**SUSQUEHANNA STEAM ELECTRIC STATION
PROPOSED LICENSE AMENDMENT
NUMBERS 279 FOR UNIT 1 OPERATING LICENSE NO. NPF-14
AND 248 FOR UNIT 2 OPERATING LICENSE NO. NPF-22
ARTS/MELLLA IMPLEMENTATION
PLA-5931**

**Docket Nos. 50-387
and 50-388**

Attachment 1 is the Technical Specifications mark-up. Attachment 2 is the associated Technical Specification Bases mark-up provided for information. Attachment 3 contains the safety analyses in support of the proposed changes. Attachment 4 is a revision for ARTS Implementation to the Plant-Specific Evaluations, provided in Reference 1, required by NUMAC PRNM Retrofit Plus Option III Stability Trip Function Topical Report (NEDC-32410P-A).

Table 3.3.1.1-1 (page 1 of 3)
Reactor Protection System Instrumentation

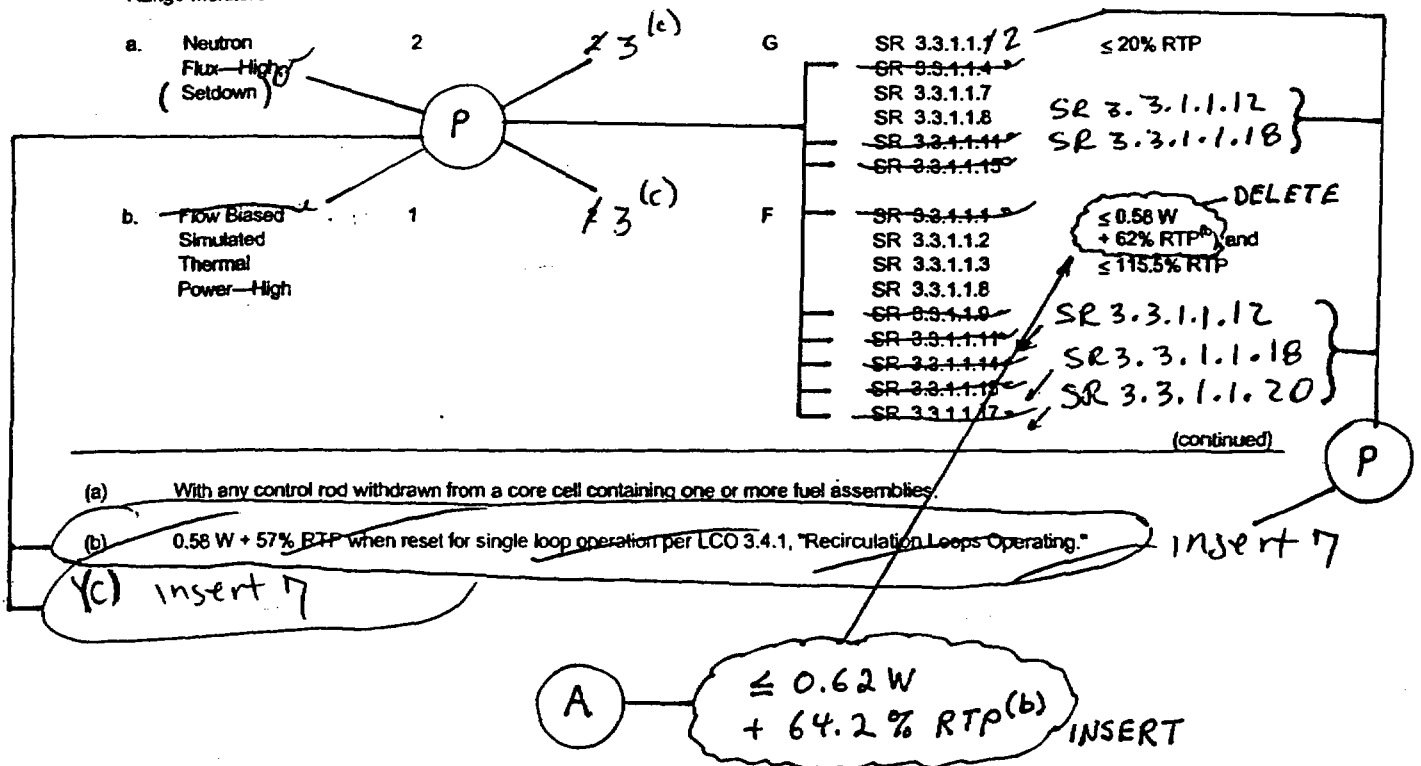
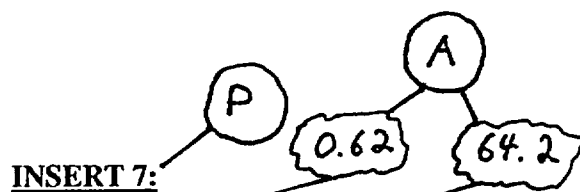
2. Average Power Range Monitors

(b) $0.58(W - \Delta W) + 62\%$ RTP when reset for single loop operation per LCO 3.4.1, "Recirculation Loops Operating." ~~For single loop operation the value of $\Delta W = 5\%/0.58$. For two loop operation, the value of $\Delta W = 0$~~

3.3-7

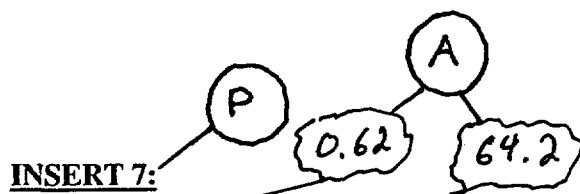
$\leq 0.62 W$
 $+ 64.2\%$ RTP (b)

(b) $0.58(W - \Delta W) + 62\%$ RTP when reset for single loop operation per LCO 3.4.1, "Recirculation Loops Operating." ~~For single loop operation the value of $\Delta W = 5\%/0.58$. For two loop operation, the value of $\Delta W = 0$.~~

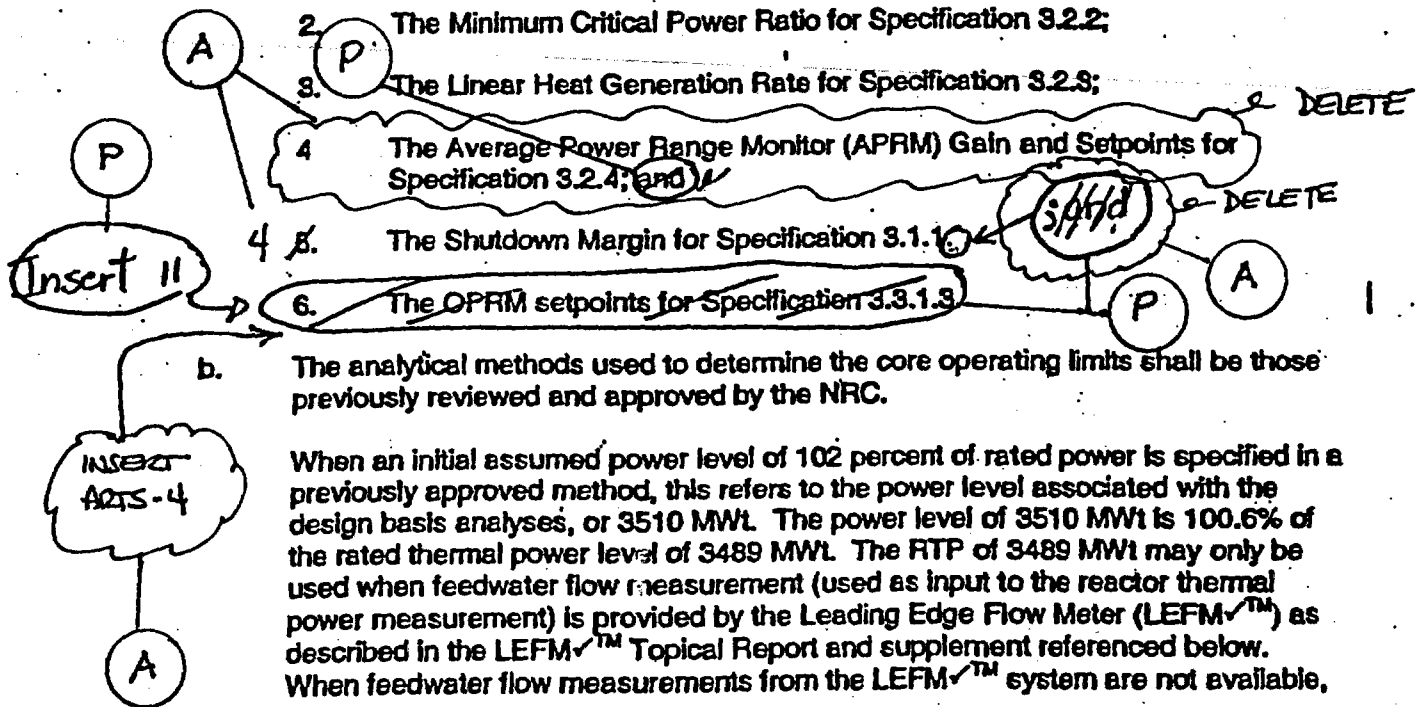
4. The Average Power Range Monitor (APRM) Gain and Setpoints for Specification 3.2.4; and

- d. Reference to the APRM Gain and Setpoints for Specification 3.2.4 would be deleted from the 5.6.5 Core Operating Limits Report (COLR).
2. APRM and RBM allowable values would be revised as follows to permit operation in the MELLLA operating domain:

Figure 1-1 ARTS/MELLLA Power/Flow Map

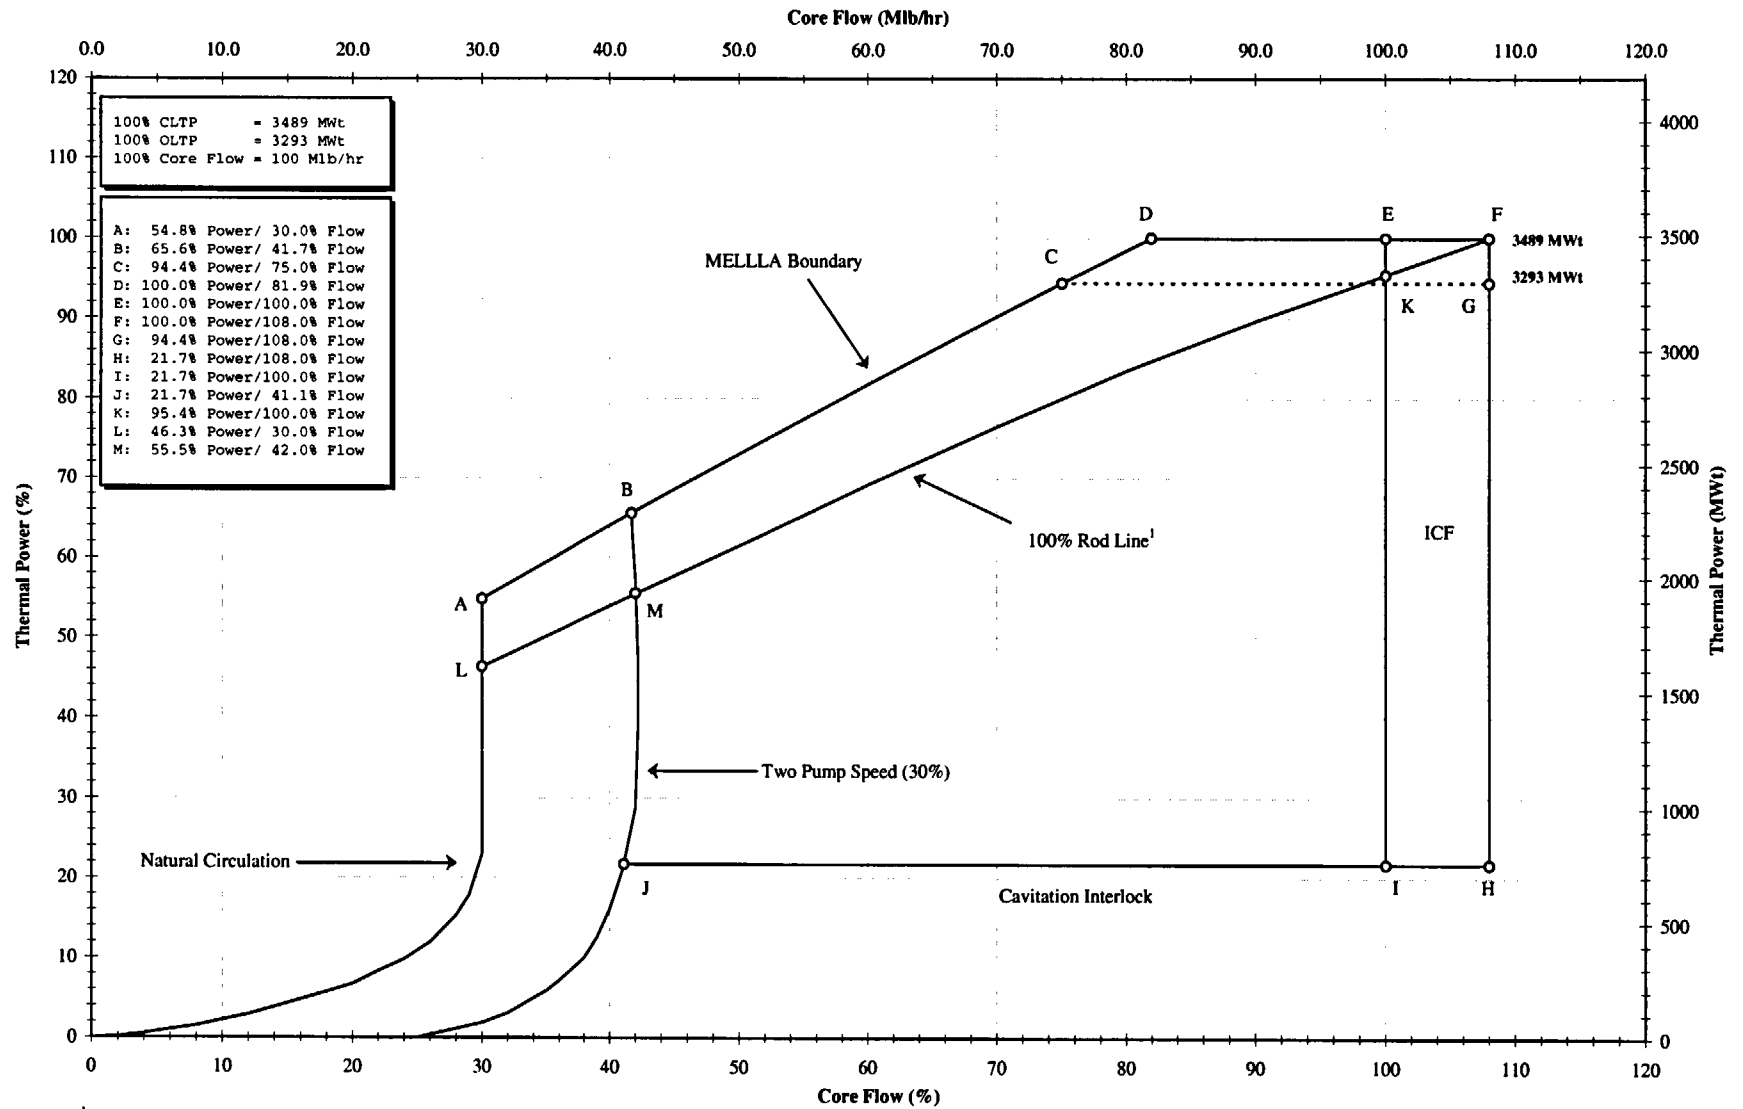
The power/flow operating map (Figure 1-1) includes the operating domain changes for ARTS/MELLLA consistent with approved operating domain improvements for other BWRs. This performance improvement application expands the operating domain along the approximate 114% rod line to 100% of RTP at 81.9% of RCF. The 114% rod line is defined relative to a 100% rod line that intercepts 100% of RTP at 100% of RCF. The 114% rod line was determined by adjusting the typical 120.8% MELLLA boundary line by the ratio of SSES Original Licensed Thermal Power (3293 MWt) to Current Licensed Thermal Power (3489 MWt). This operating domain is defined by the following boundary:

SSES is currently licensed to operate at an ICF of up to 108% of RCF (108 Mlbs/hr) at 100% of RTP. For MELLLA operation, the rated power output remains the same, but core flow is reduced to 81.9% of RCF at 100% of RTP as shown in Figure 1-1.
